ADDENDUM #2

Date:	25 March 2008	
To:	General Contractors	
From:	Bill Bowen, Project Manager, DFCM	
Reference:	Weber State University Hurst Center for Lifelong Learning	
DFCM Project #:	07110810	
Subject:	**Addendum No. 2**	
Pages:	Addendum	1 page
	Substitution Request	16 pages
	Architectural Addendum	38 pages
	Total Pages	**55 pages**

A1 STOR. SILL FLASHING DETAIL
SCALE: 6" = 1'-0" AE520 A-DTWN10

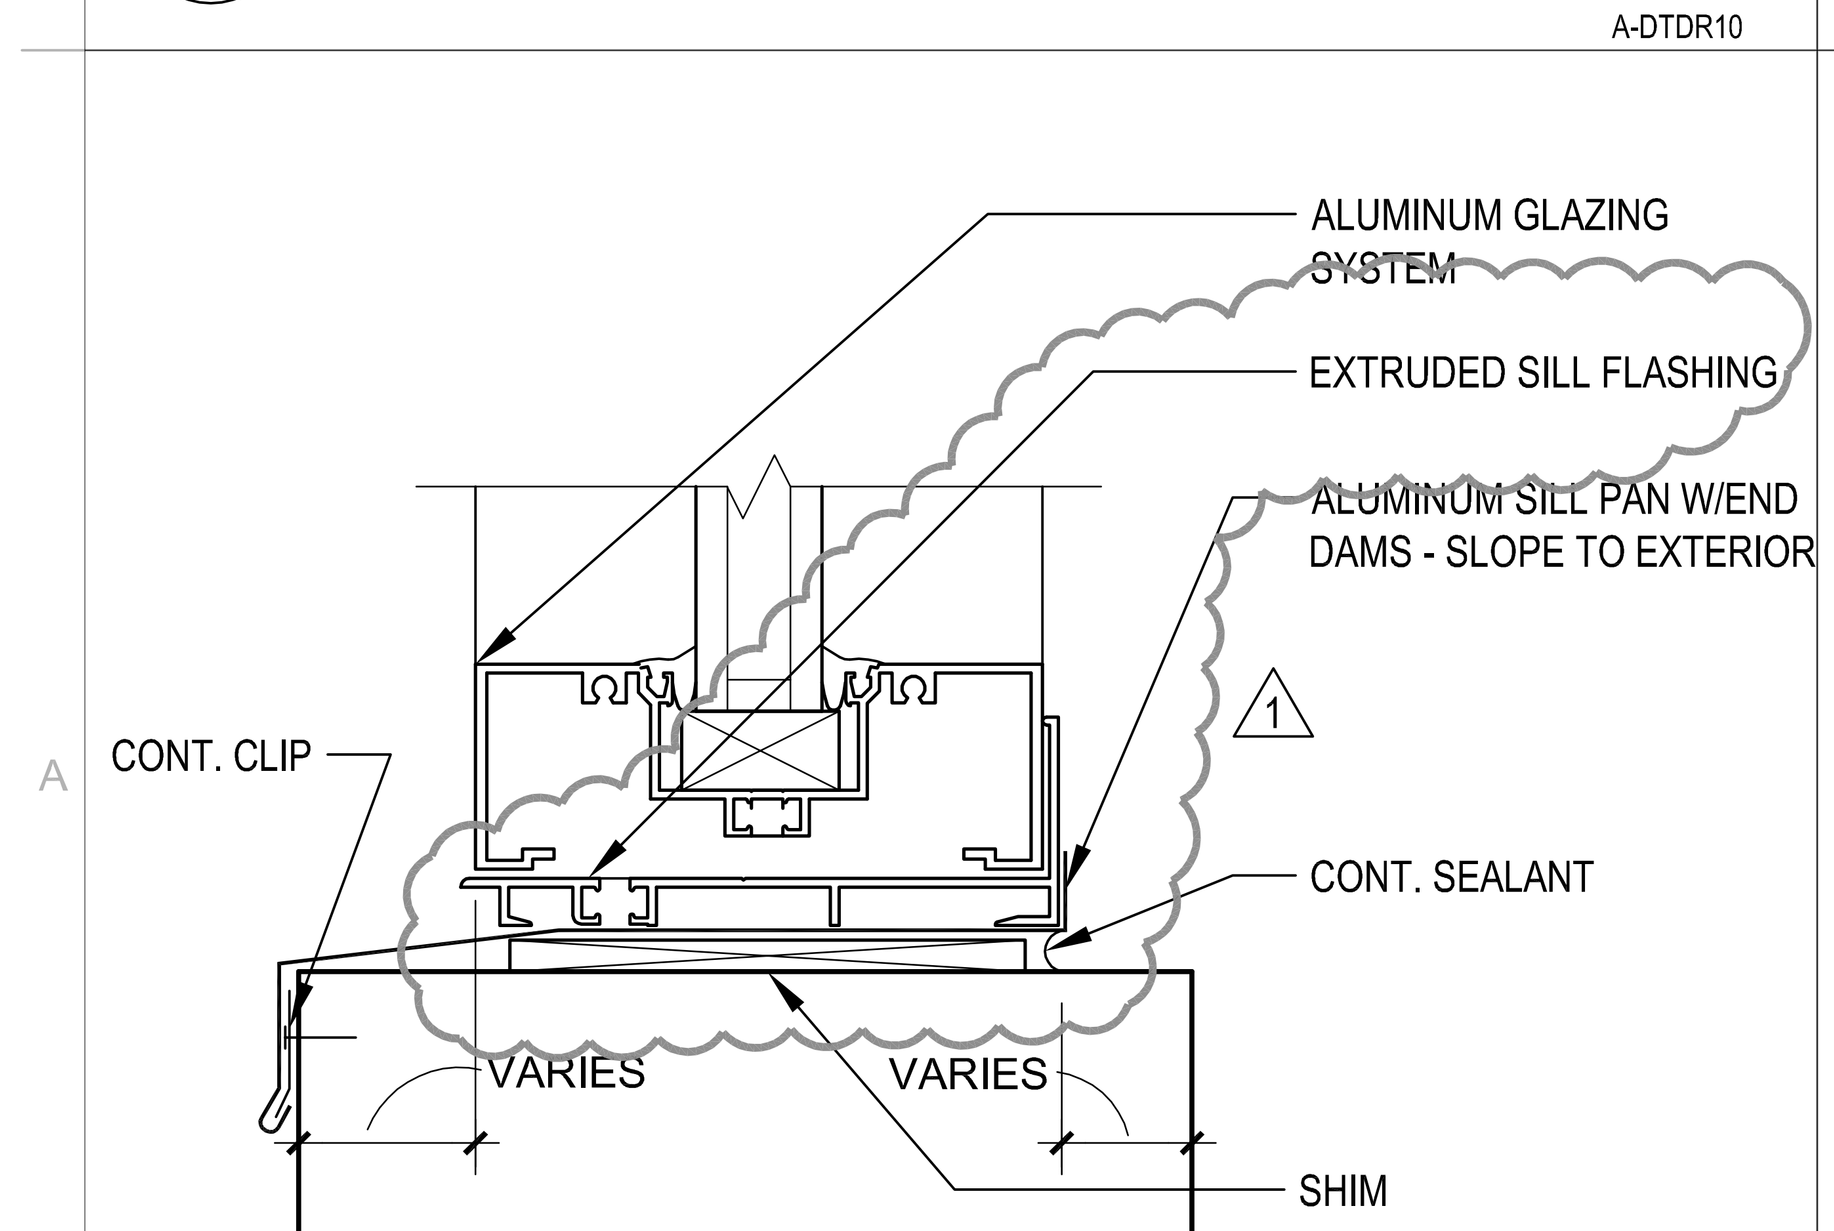
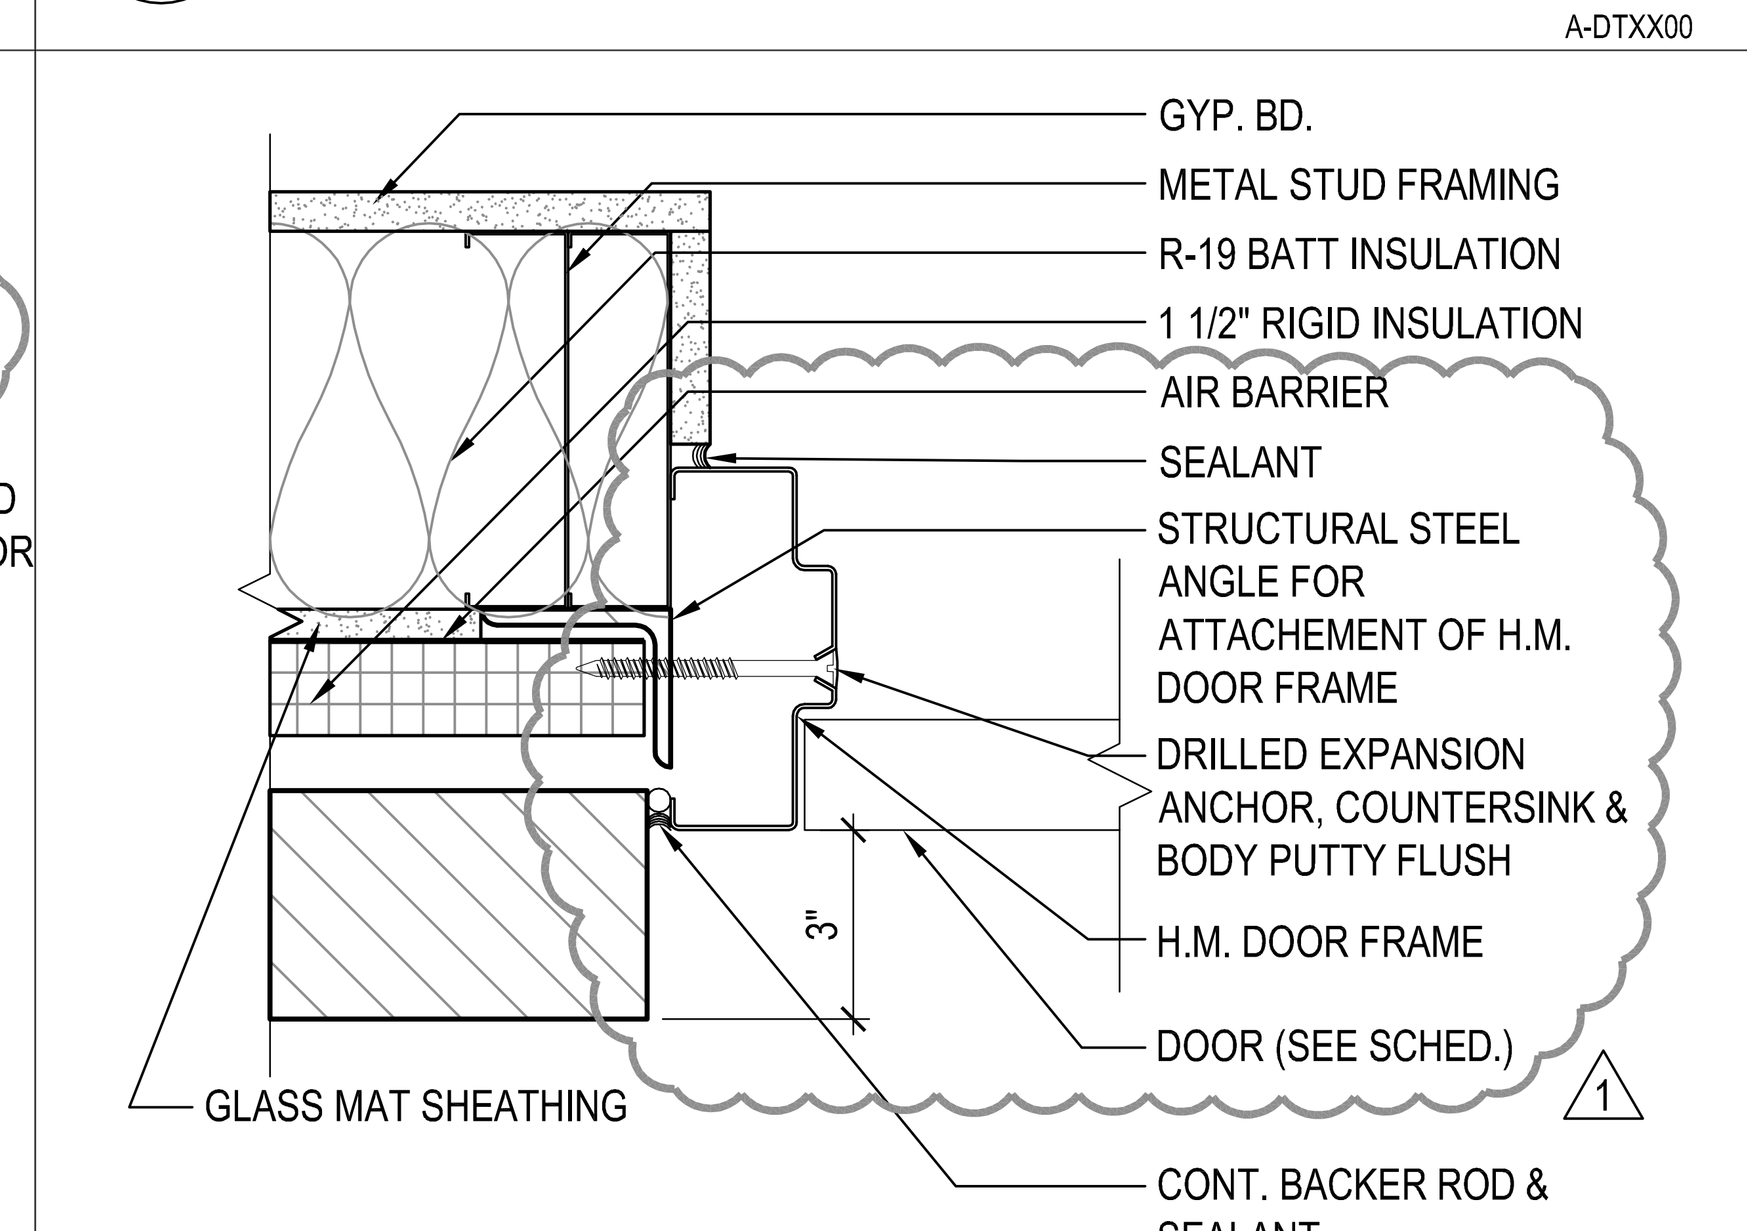
A2.45 Sheet AE520: Replace sheet with new AE520. Delete detail D4. Revised details D2, C2, B1, B2, A1, A2 and A3.

WINDOW TYPE 16

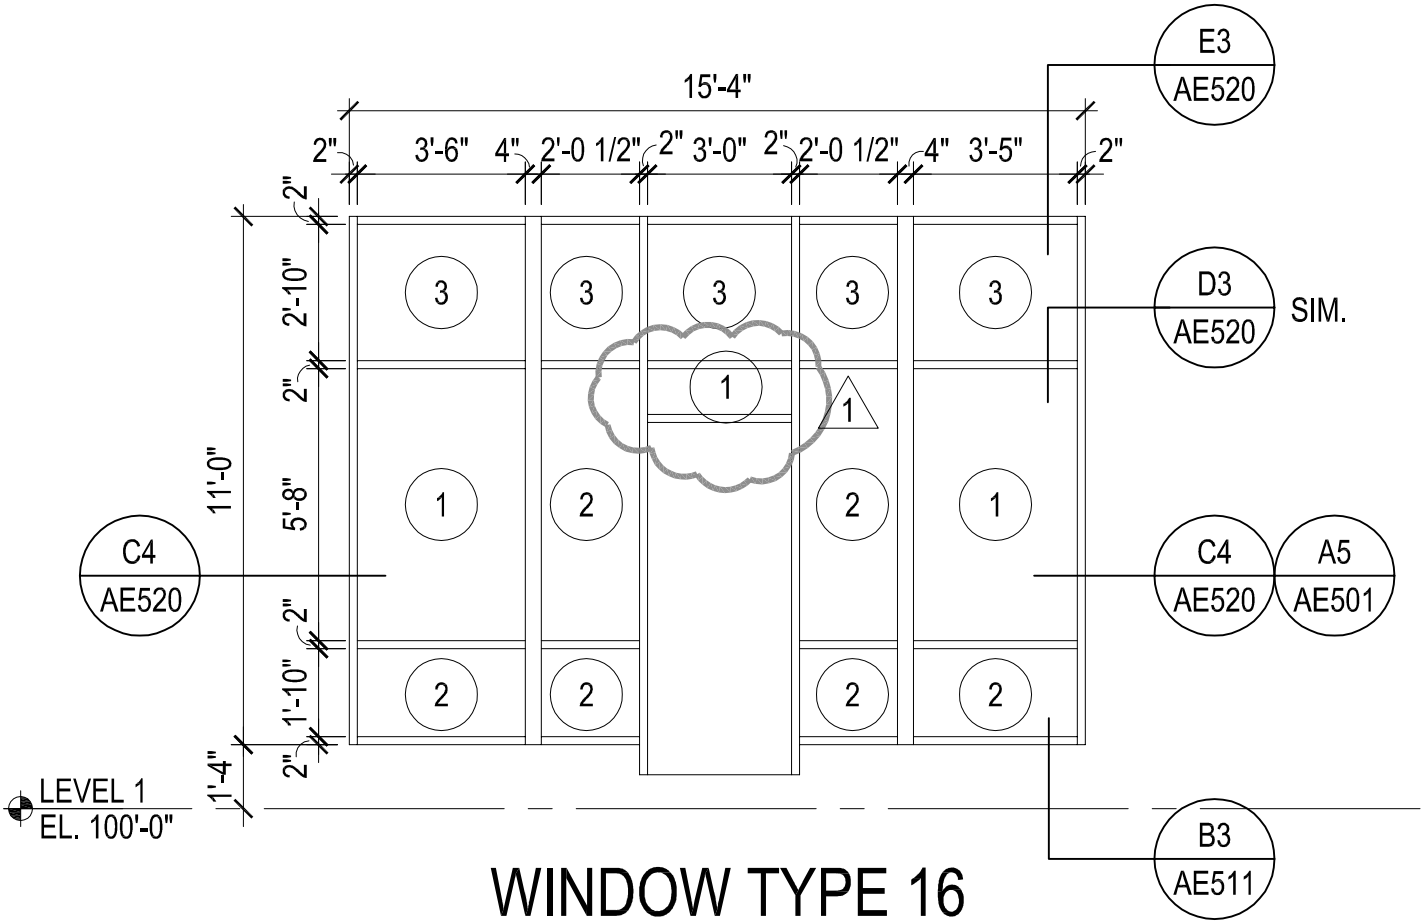
A2.48 Sheet AE631:
- Window type 16 – refer to sketch AD02-A05 for revisions to window type.
- Window type 17 – refer to sketch AD02-A06 for revisions to window type.

Sheet No.
MSD-02
Sheet Reference
MH602

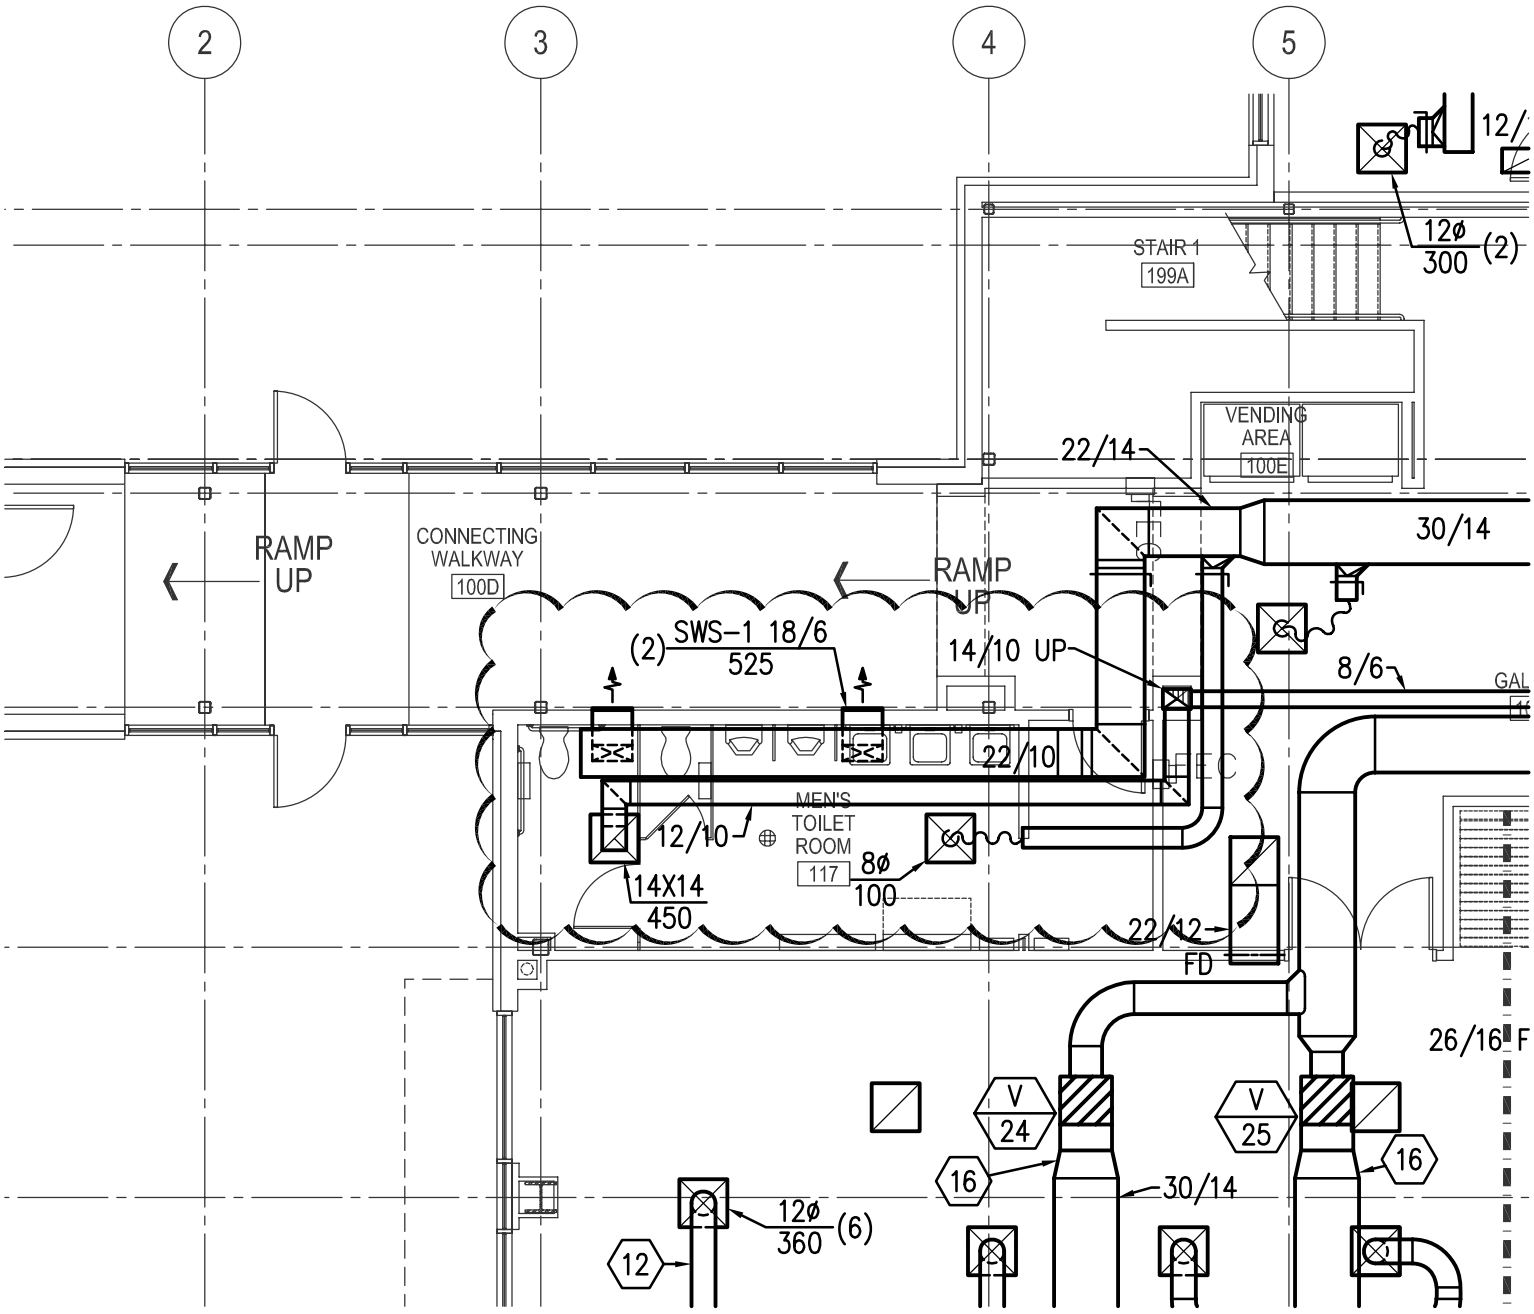
A2.52 Sheet MH602
- Air Handler Schedule: See attached drawing MSD-02 for a schedule of sound data.
